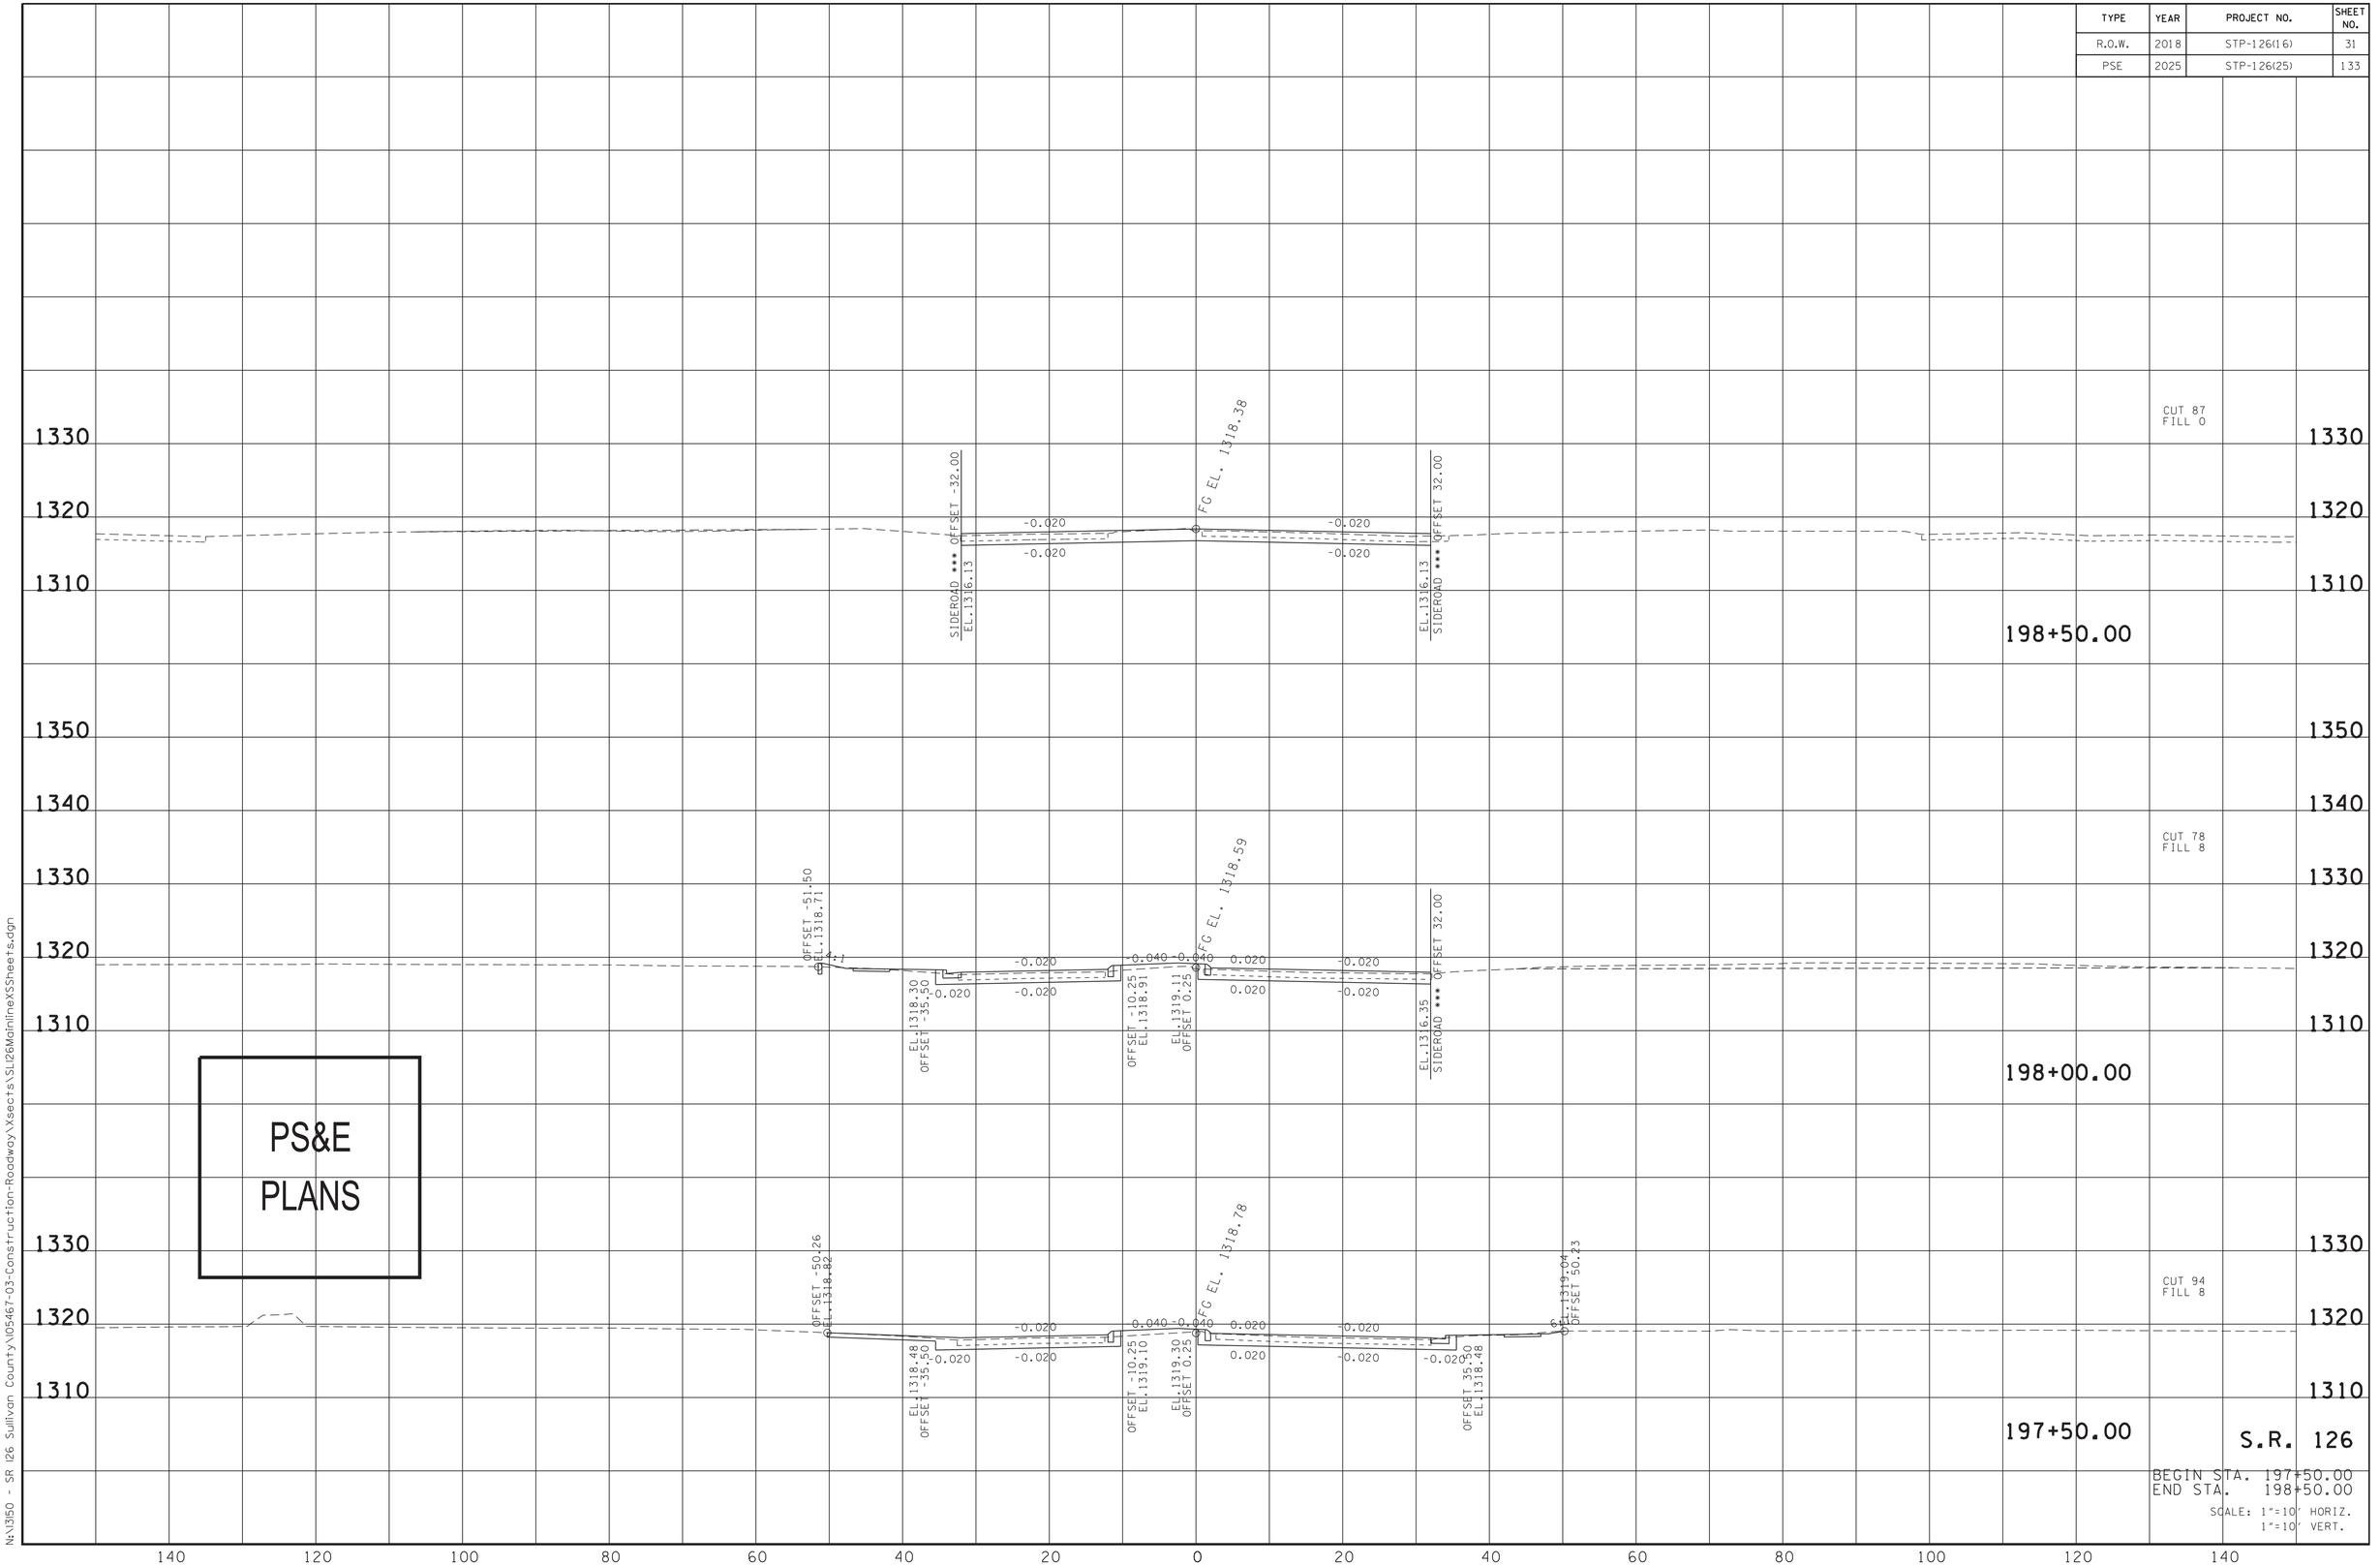
SUPERELEVATION TRANSITION ADJUSTED TO
MOVE LOW POINT OUT OF ENTRANCE.
REVISED CROSS SECTIONS 200+50 THROUGH 202+50
4-30-2021:

SUPERELEVATION TRANSITION ADJUSTED BACK TO
INITIAL DESIGN WITH ONE-THIRD OF THE EB RUNOFF
INSIDE THE CURVE.

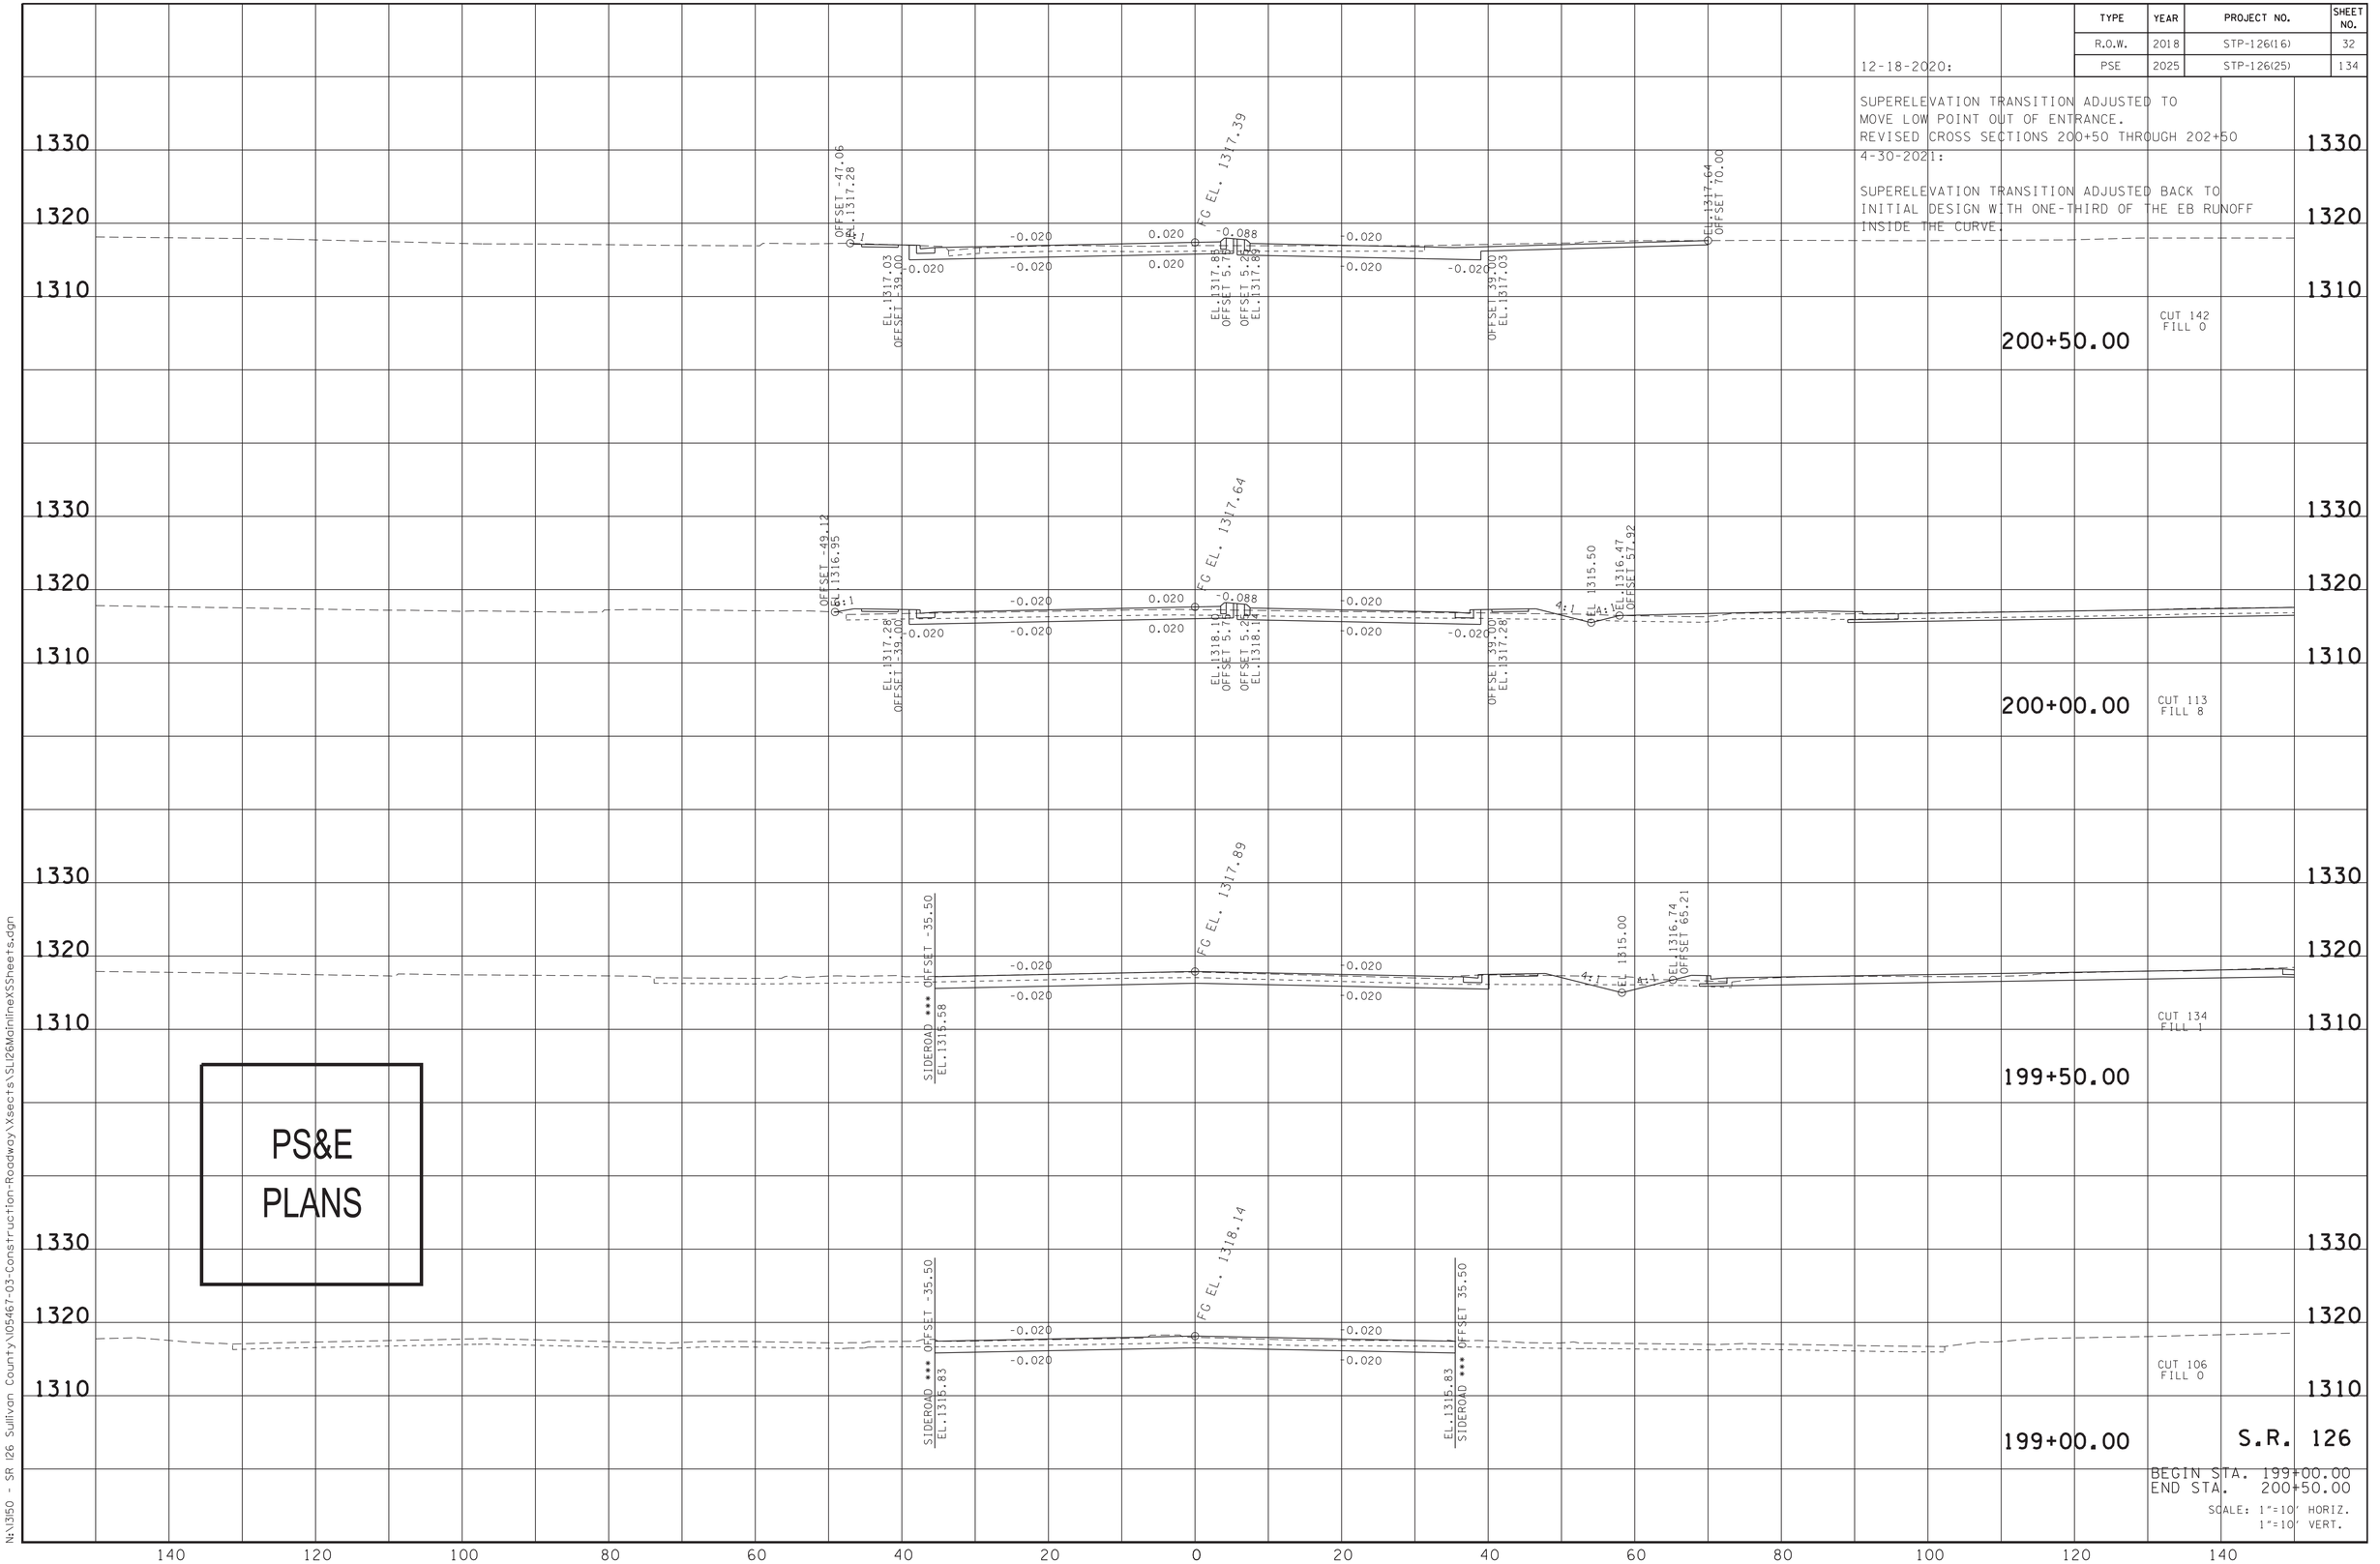
4-30-2021:

SUPERELEVATION TRANSITION ADJUSTED BACK TO INITIAL DESIGN WITH ONE-THIRD OF THE EB RUNOFF INSIDE THE CURVE.

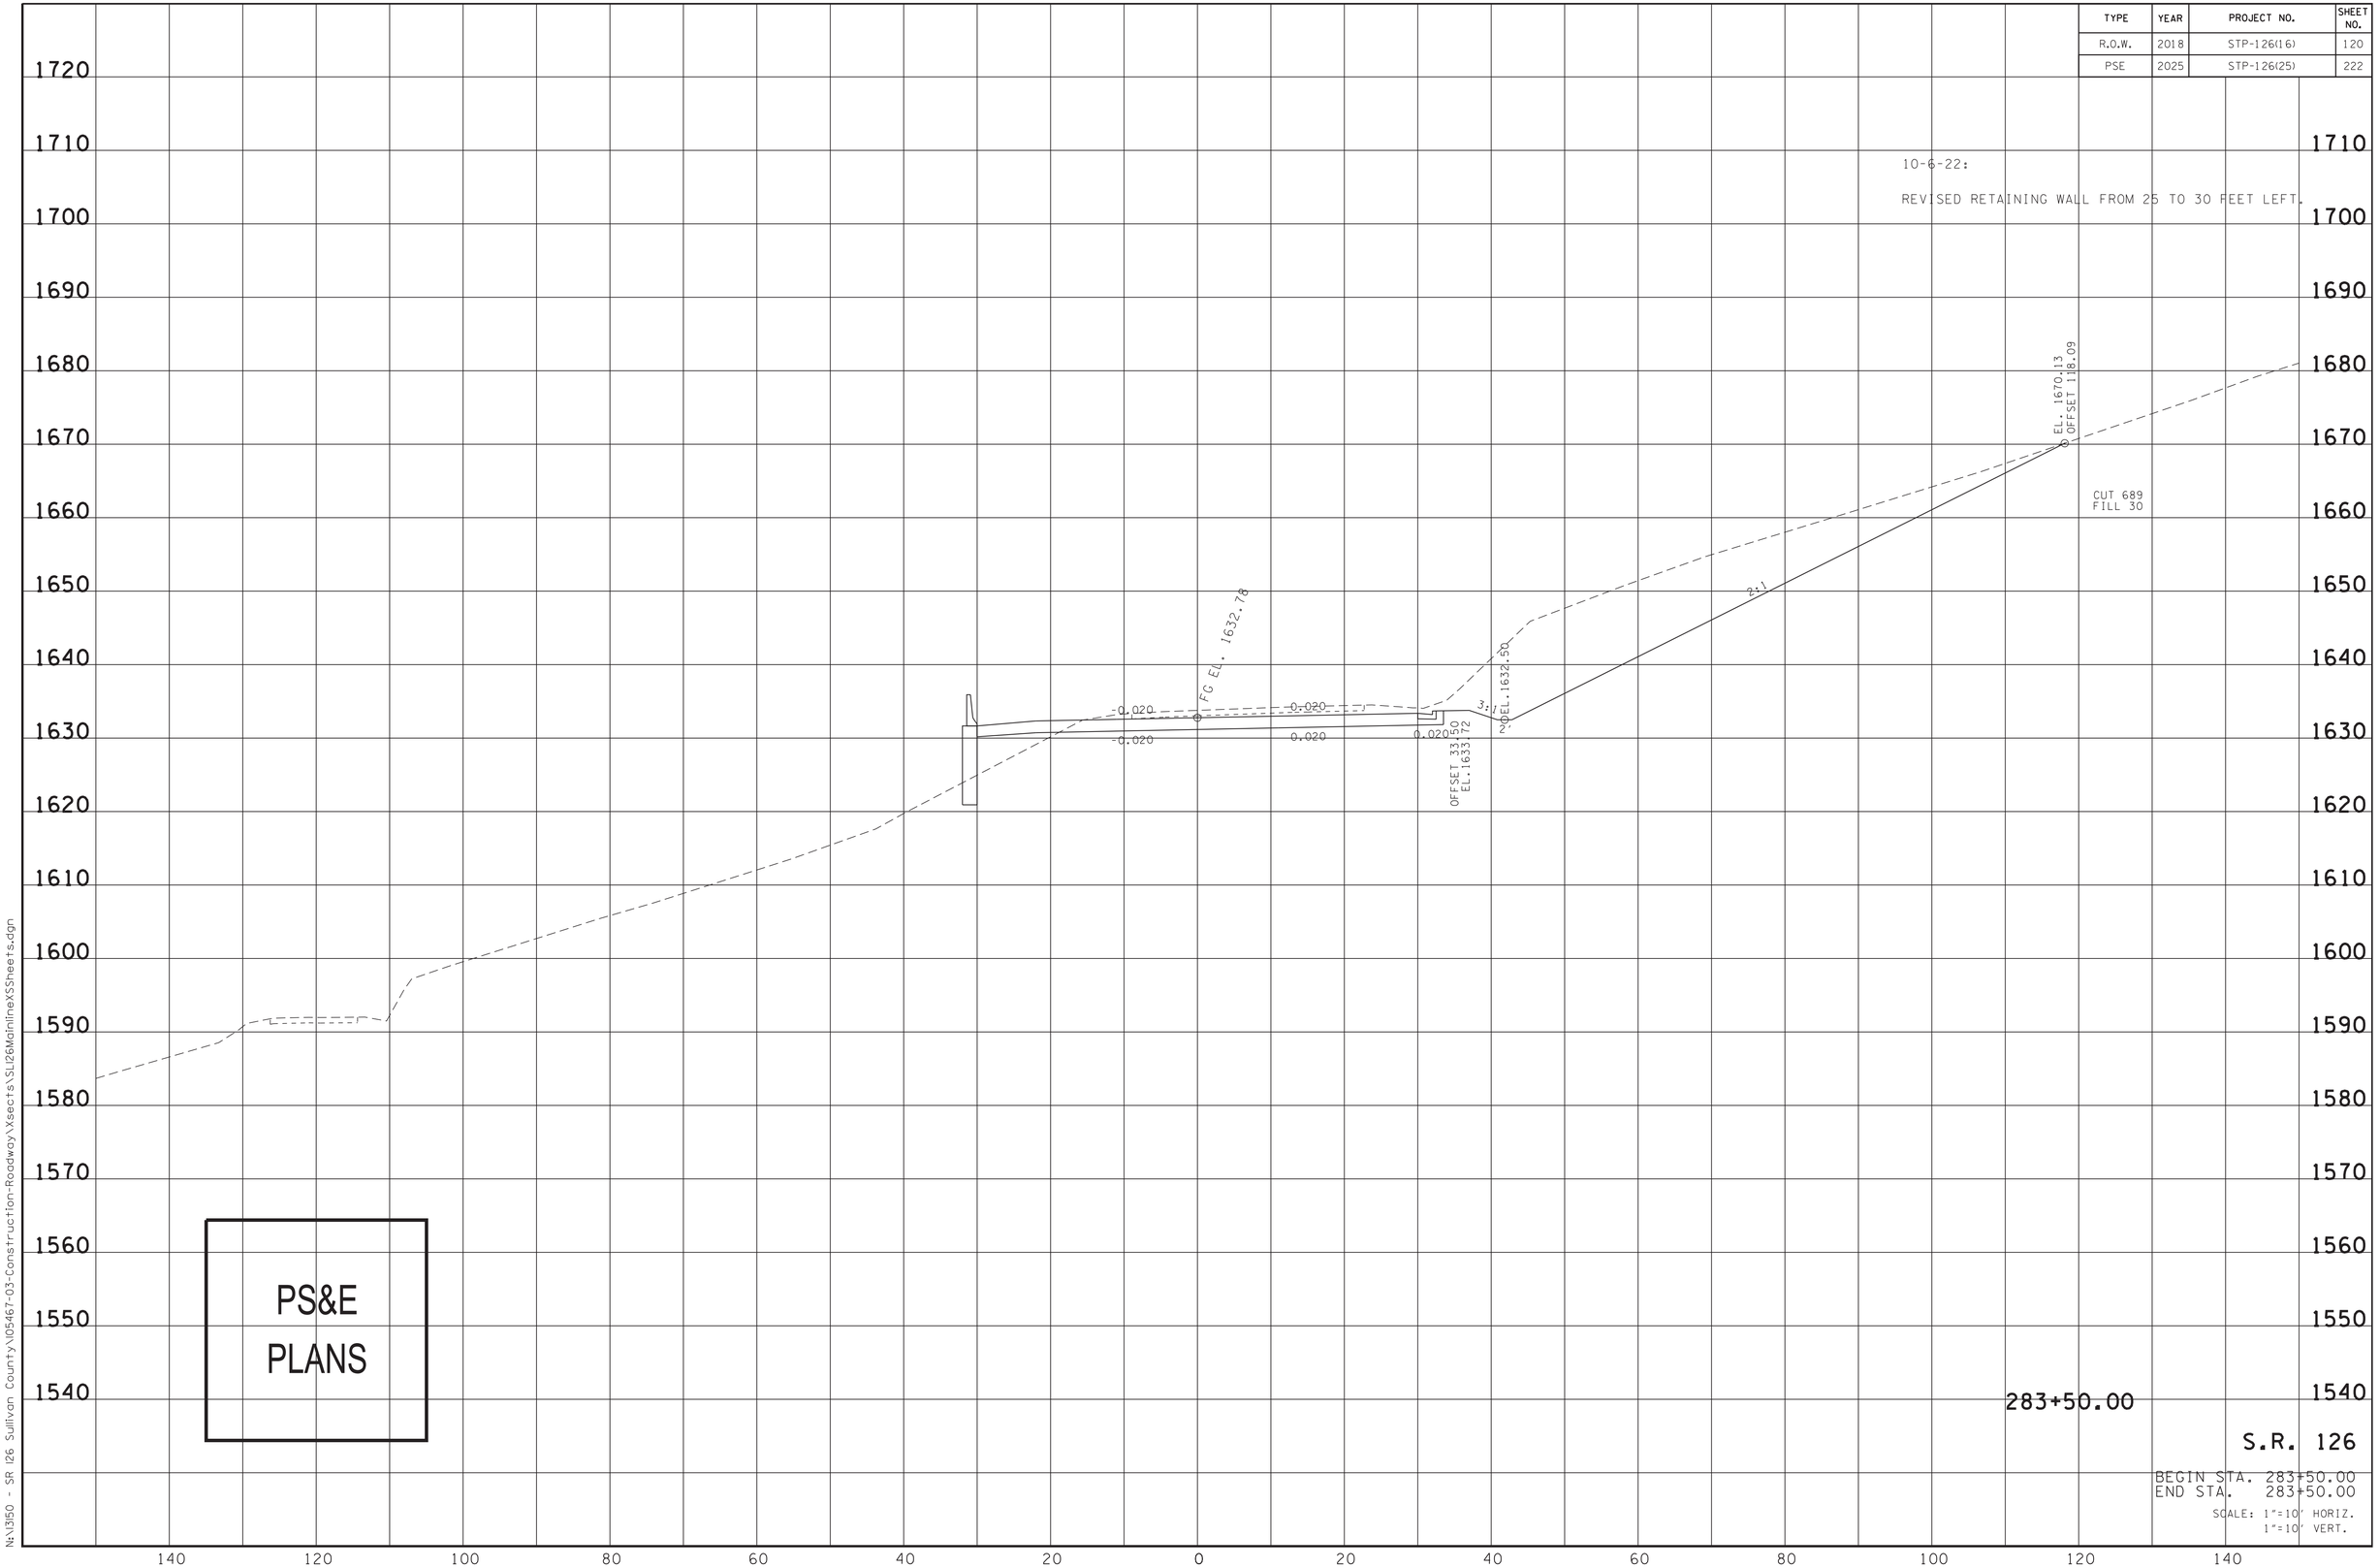
10-6-22:

REVISED RETAINING WALL FROM 25 TO 30 FEET LEFT.
